USA Appln. No. 09/022,336  
Applicant: William E. M. Jones et al  
December 3, 2001

#### **REMARKS**

FIG. 3

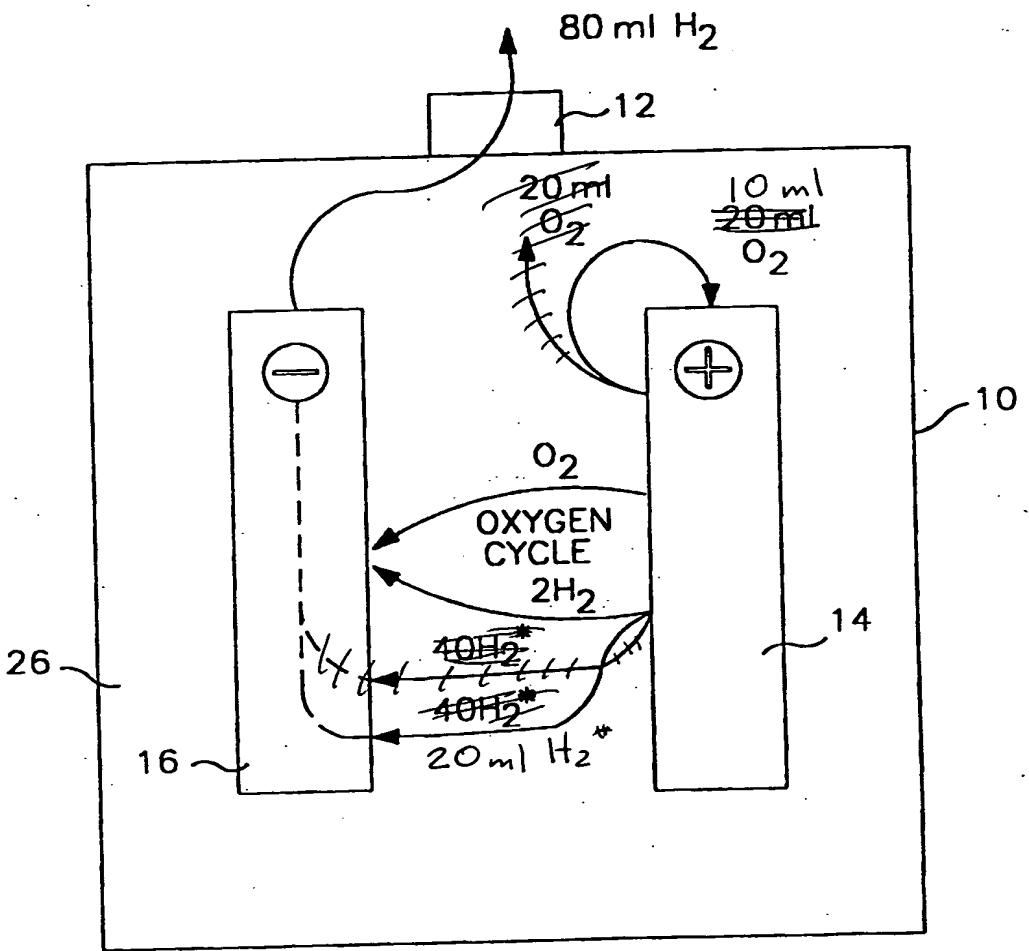
Proposed Figure 3 submitted herewith was changed to depict that only 10 mL per day of oxygen is being consumed by the corrosion reaction, generating only 20 mL per day of hydrogen of the 80 mL needed for the negative plate self-discharge reaction. This is disclosed in the originally-filed specification at page 10, lines 31-39. The corrections to Figure 3 conforms the drawing to the specification and do not introduce new matter.
